Remarks/Argument

Response to Examiner's Remarks in Detailed Action

Amendments to the Drawings

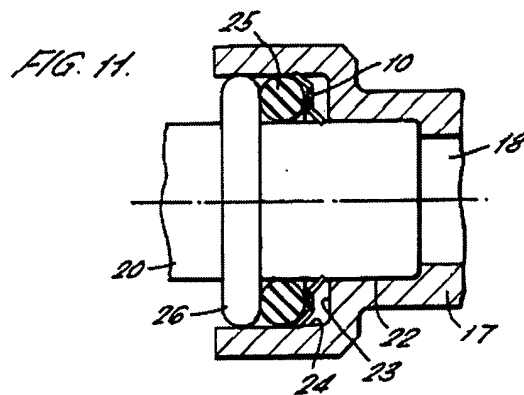
The Examiner refers to element 26 in Guest as the “compression gland,” with reference to Guest’s Figure 11. Figure 11 of Guest is reproduced below:

In this image, the element 26 appears to be a band affixed to the first male pipe portion. The language used by Guest to refer to this element is “encircling bead 26” or simply “bead 26”. (See column 3, lines 35 and 37). See also (for example) Figures 13-15 of Guest, in which the bead is shown in the same static position on the pipe 20, regardless of stage of installation or insertion into the bell. Applicant contends that those in the industry would understand each of Figure 11 and the text cited above, to refer to a “weld bead” configuration. In the piping industry, it is common in some applications to permanently affix a raised surface in the form of an affixed ring welded about the spigot. This is frequently accomplished by welding a ring to the spigot surface, or simply depositing a circumferential bead of weld metal about the spigot. In operation, the spigot is then inserted into the female pipe portion beyond the location of the band or bead, and then a blocking device is somehow affixed. It is clear that this is the intended function of the bead 26 in Guest, as evidenced not only by the understanding in the industry, but also by fact that Guest itself suggests that the bead 26 is properly considered permanently and

Understanding this known methodology and structure for locking pipes, the band 26 referred to by Guest appears to be just such a weld bead or affixed band. Significantly, this bead is understood to be affixed directly and immovably to the spigot. This is not a compression gland, and does not perform the function of a compression gland. Being affixed permanently in immovable relationship to the spigot, the bead cannot move as a compression gland does. Moreover, the bead is permanently affixed to the spigot, rather than being "securable to the second female pipe portion" as required by the claim.

FIG. 1
PRIOR ART

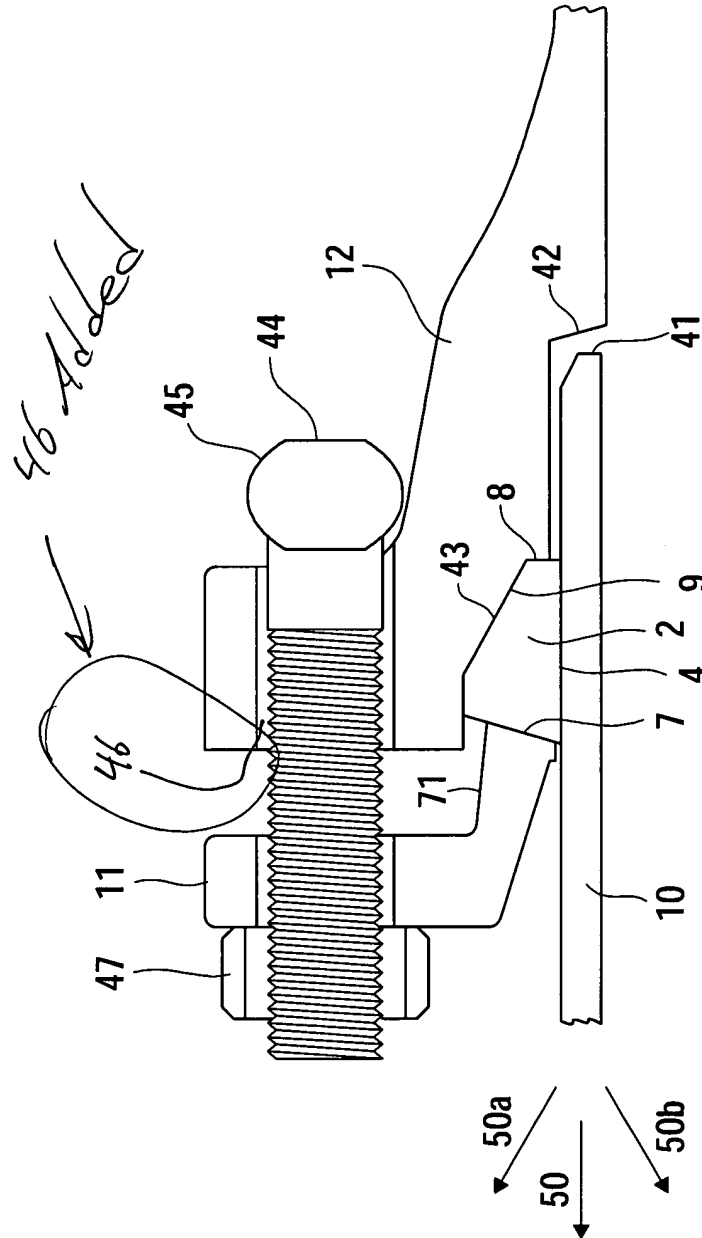
Figures 1 and 4: Reference numeral 46 has been added. Figure 4 shows biting of the segment into the bell.

FIG. 2

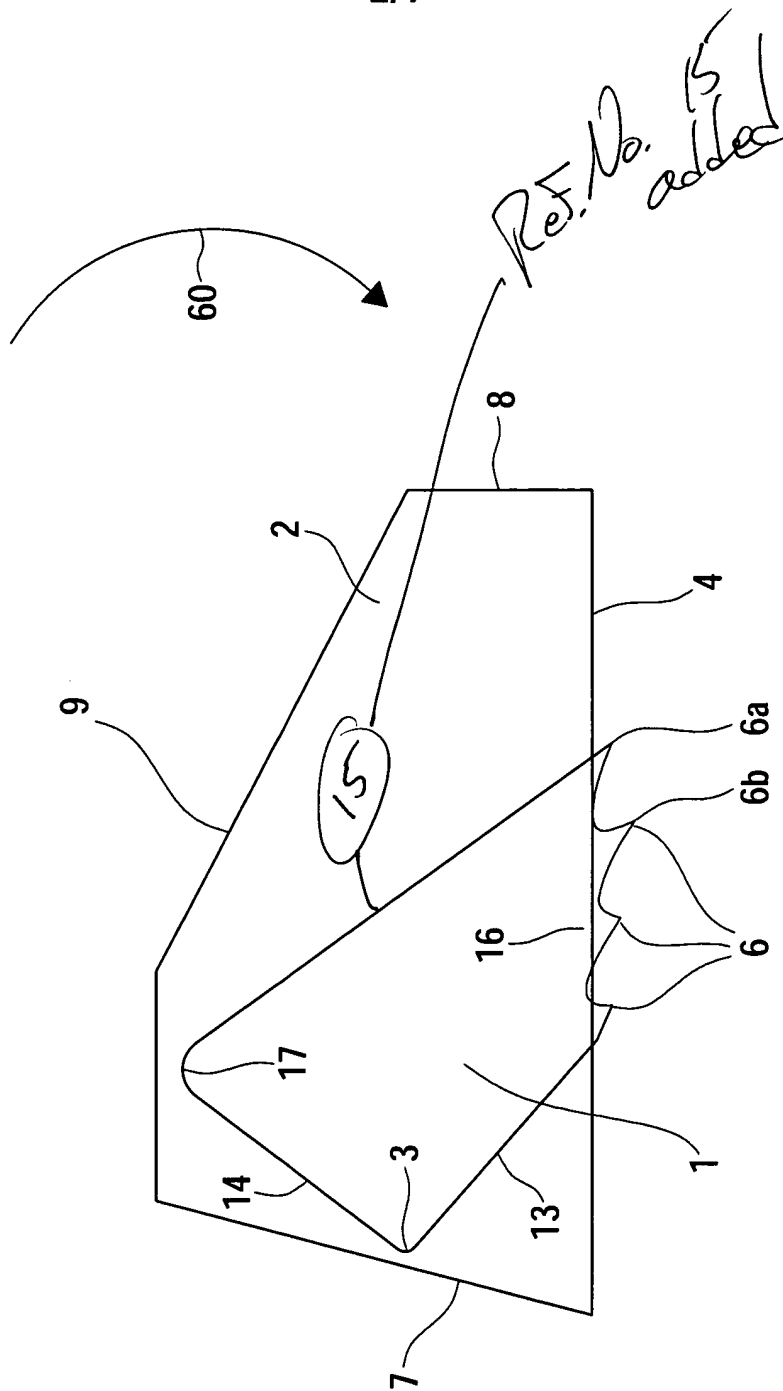
Figure 2: Reference numeral 15 (shown in Figure 7) has been added for ease of the reader.
